MIL-D-82035C
AMENDMENT 2
25 March 1988
SUPERSEDING
MIL-D-82035C
AMENDMENT-1
20 August 1986

DISPENSERS, BEVERAGE, MECHANICALLY REFRIGERATED

This amendment forms a part of Military Specification MIL-D-82035C, dated 23 March 1984, and is approved for use by all Departments and Agencies of the Department of Defense.

"1.3 Definitive specification part number. The specification part number is definitive to identify each item covered by selecting from the options available (see 1.2). The part number is formatted and designated as follows:

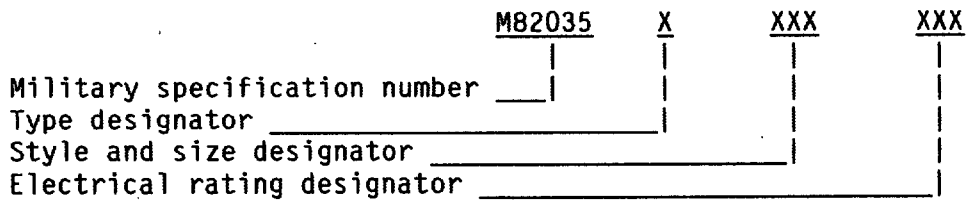
Add:

Option		Designator
Type		
I		1
II		2
Style	Size	
A	4	A04
A	7	A07
A	13	A13
B	7	B07
B	11	B11
Electrical rating		
115/1/60		
220/1/50
